ATTACHMENT 3

PROPOSED TECHNICAL SPECIFICATIONS

Marked-up Technical Specifications Pages,

~~FIGURE 3.1-2~~

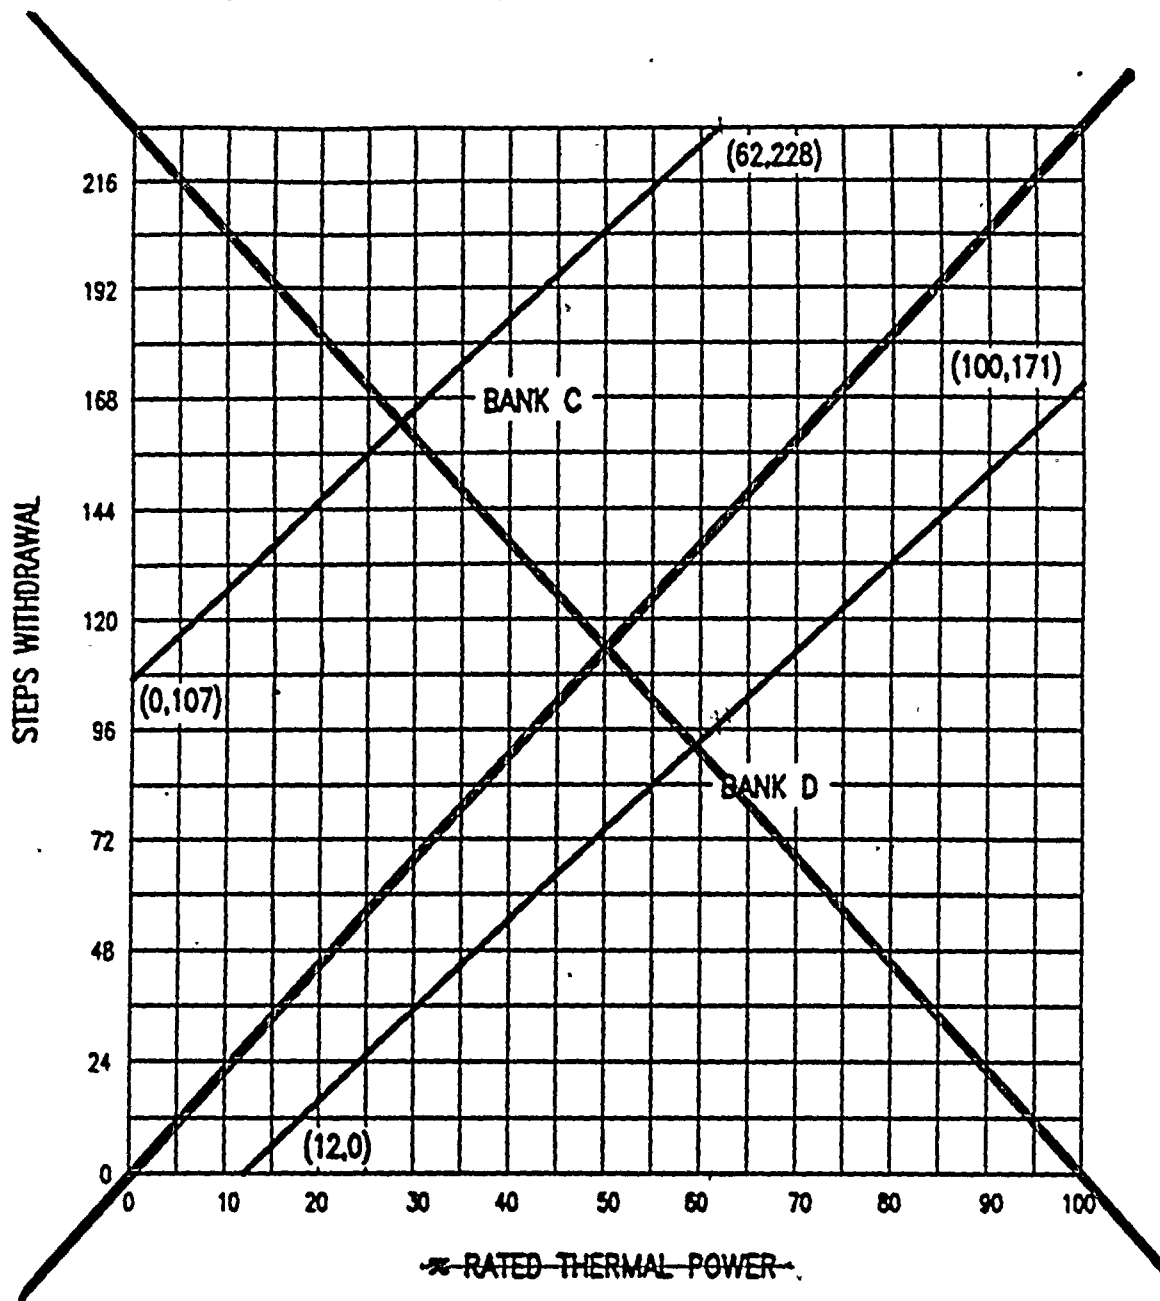
3.1.3.6 The control banks shall be limited in physical insertion ~~as shown in Figure 3.1-2.~~ **INSERT (1) - HERE**

**DELETE**

~~ROD BANK INSERTION LIMITS VERSUS THERMAL POWER  
THREE LOOP OPERATION~~

INSERT 1

specified in the Rod Bank Insertion Limits curve, defined in the CORE OPERATING LIMITS REPORT.
